Damage to vacuum pumps through incorrect assignment

Vehicle	Product: Vacuum pump	
	PIERBURG No.	O.E. No.*
VW Transporter LT, T4 (pickup, window van, panel van, California) Engine code: AAB	7.22300.62.0	075 145 100 ; 075 145 101; 075 145 101 A
	7.22300.69.0	074 145 100 A

Fig. 3: Position of the camshaft during installation

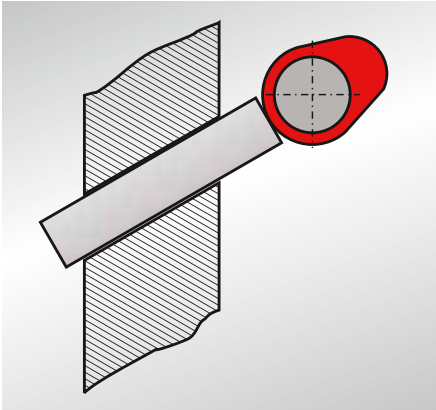
During installation work the cam of the camshaft which drives the vacuum pump must be located at the opposite side of the intermediate tappet rod (see Fig. 3) so as to be able to install the pump under a slight pre-tension only (gap of 2 mm max.):

Fig. 5: In the case of a wrong assignment, proper installation will not be possible

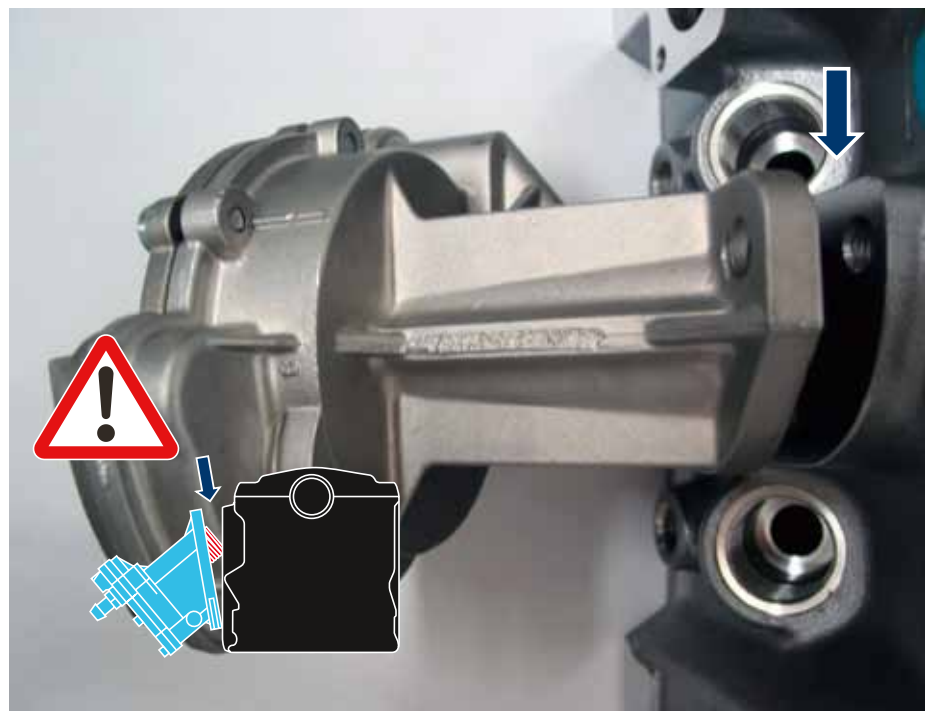
If the vacuum pump cannot be pressed onto the flange without exerting a significant amount of force (gap 5 mm approx.) although the cam is located at the opposite side of the intermediate tappet rod you can be sure that the assignment is wrong.

- !** Never try to resolve this problem by modifying the intermediate
- tappet rod (by grinding, for example)

- !** Under all circumstances check
- vehicle identification number
 - registration date and/or
 - part number of the old pump!
